SEWAGE DISPOSAL SYSTEM

MARYLAND STATE DEPARTMENT OF HEALTH

SUBDIVISION ROAD 1650 Marriottsville Road OT

SPECIFICATIONS - barn and training arena - NO LIVING QUARTERS TO BE IN THIS HORSE BARN

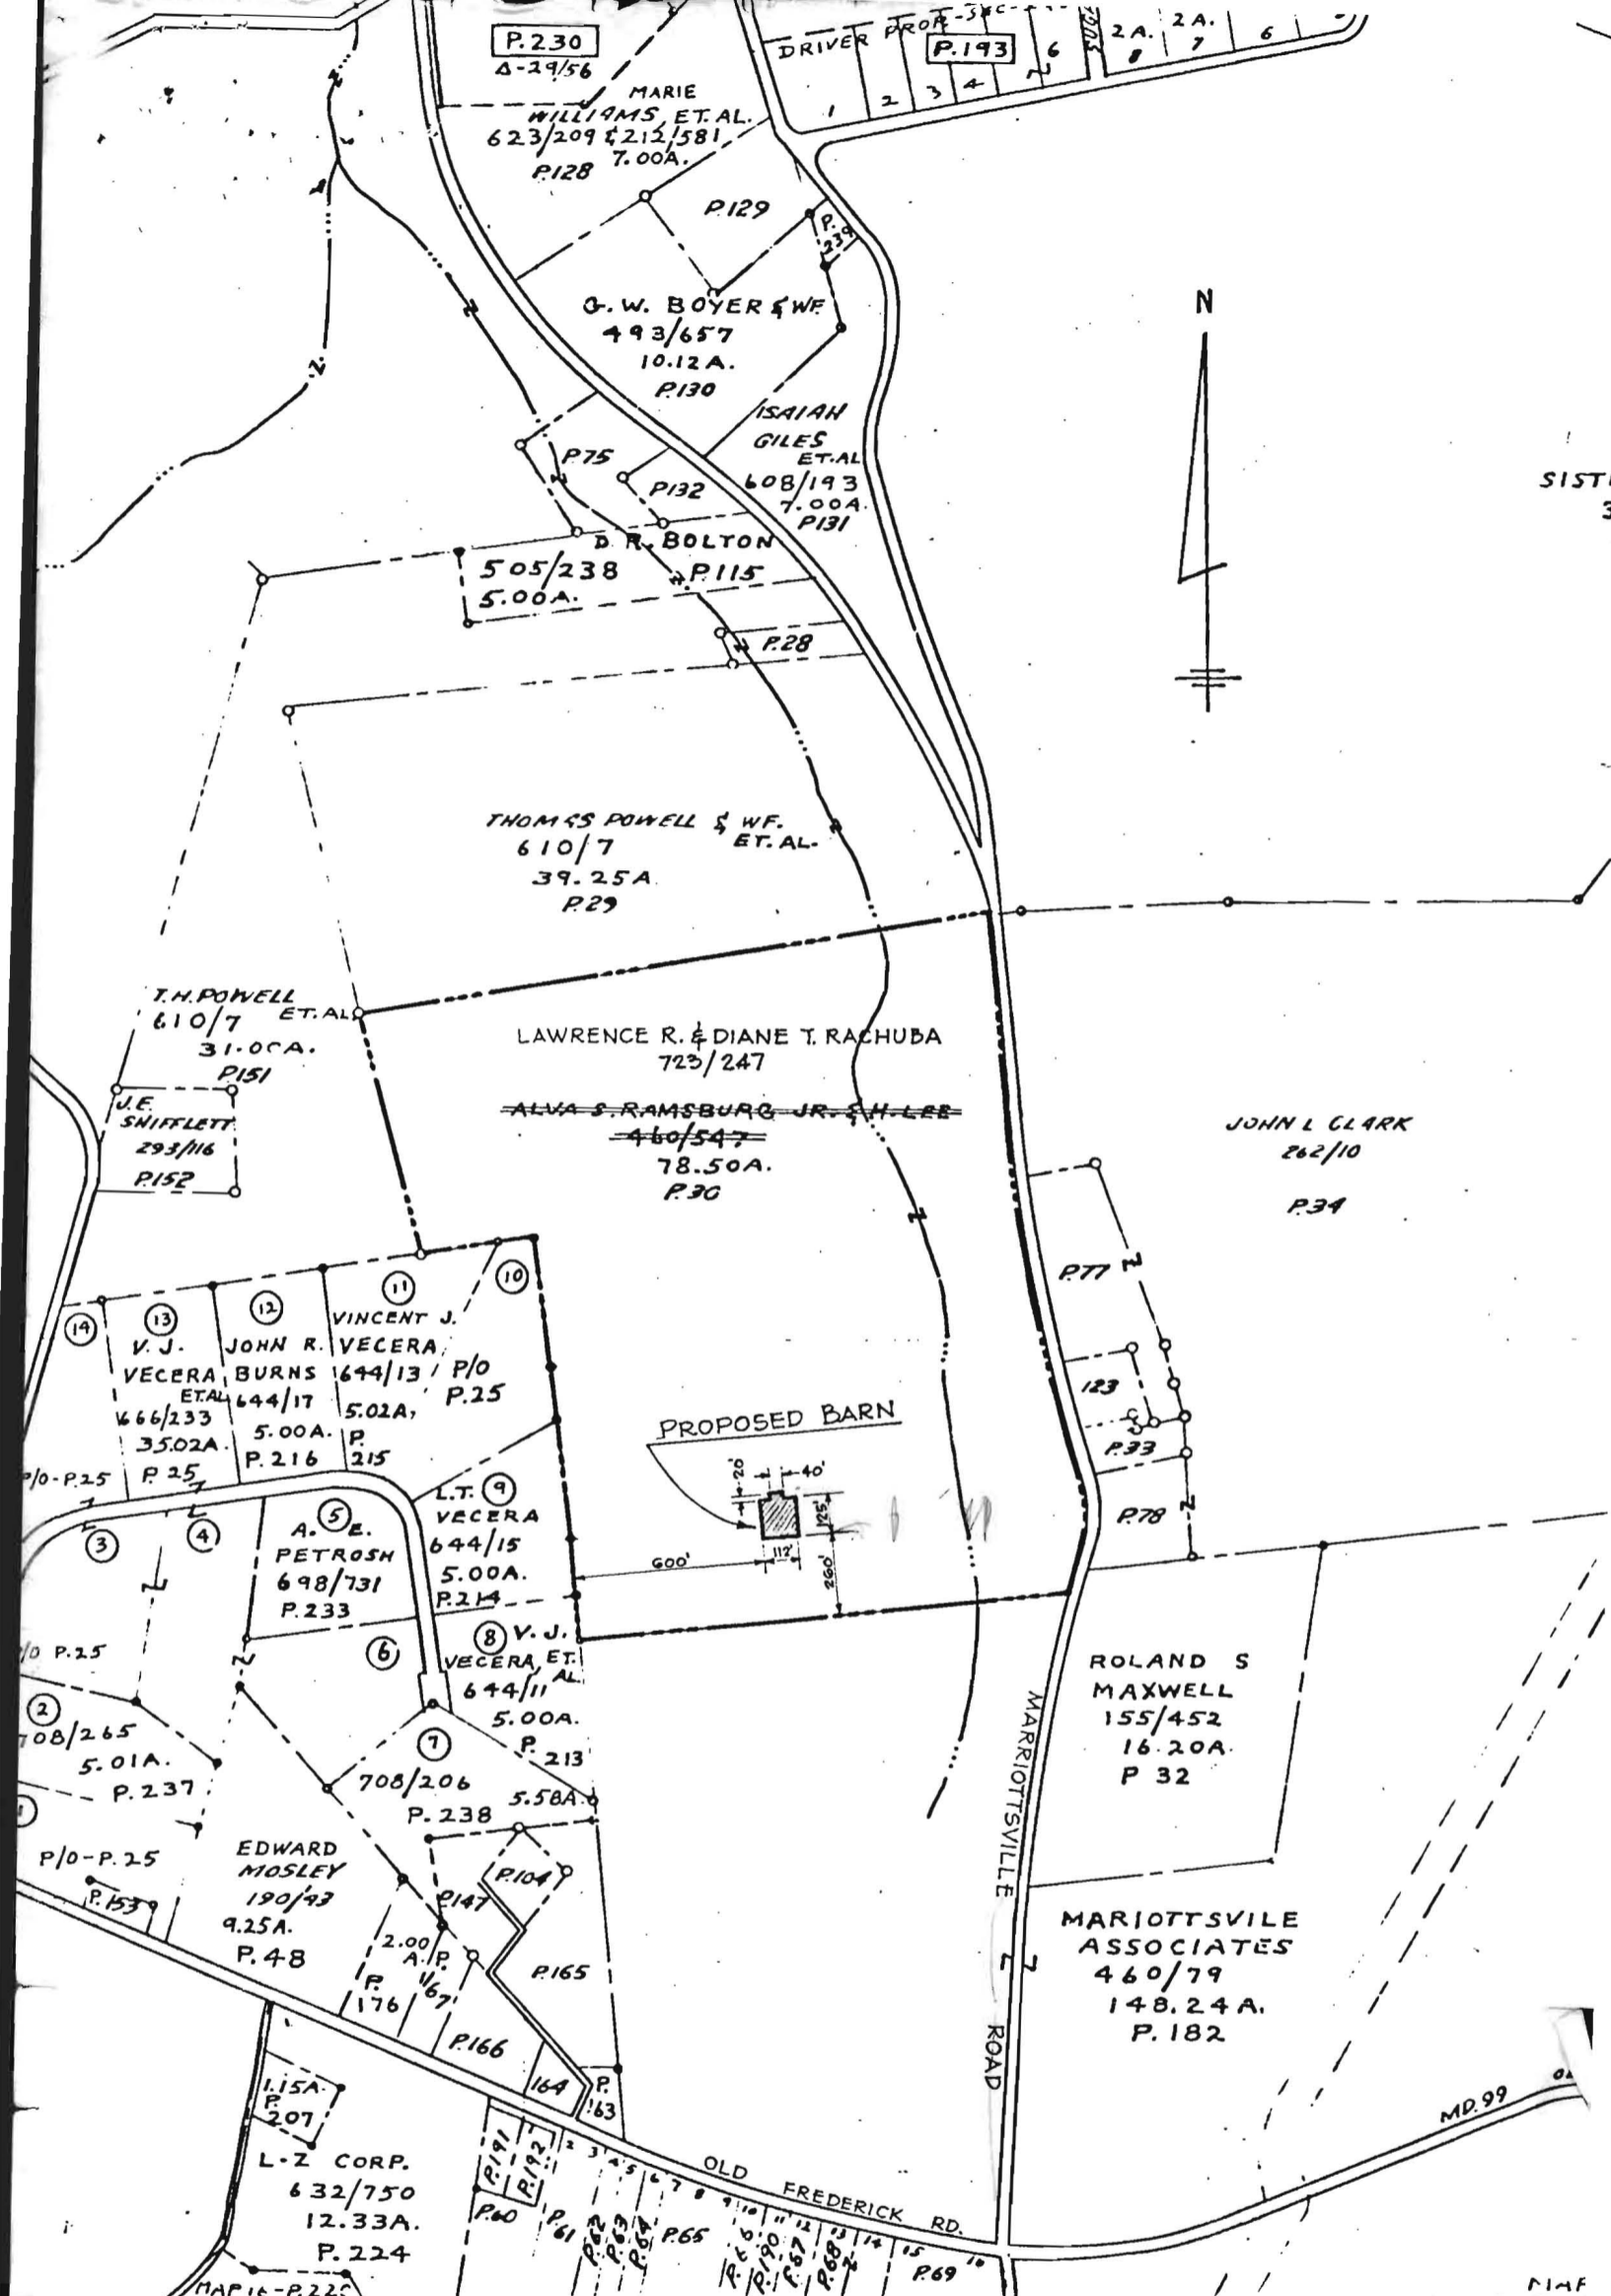
MAY 24 1976 - @ 10:45 - cap on cleanout not installed
Recall Fri, May 28 1976 - Remove Final

ST	line
1	3 At bends
CLEANOUTS <u>NO</u>	
5/28/76 } 1 loose cap Cleanout	
No cap on 1 cleanout	
so No change from	
5/24/76. C.B.D.

REMARKS 5/11/76 - DITCH OK. ADD STONE/FINISH JOB R/H
OK TO COVER PART OF HOUSE SEWER FOR TRAFFIC R/H
5/14/76 - DITCH & TANK OK. OK TO COVER
PART OF HOUSE SEWER. CALL FOR INSPECTION
OF REST OF SEWERS & CLEANOUTS R/H

MAY 20 1976 - ok to cover all cast iron sewer pipe - need
to cover plastic drain field pipe w one layer of stone then
 DATE SYSTEM APPROVED MAY 21 1976 INSPECTOR hal benson
 PAPER. then call ND for final inspection over
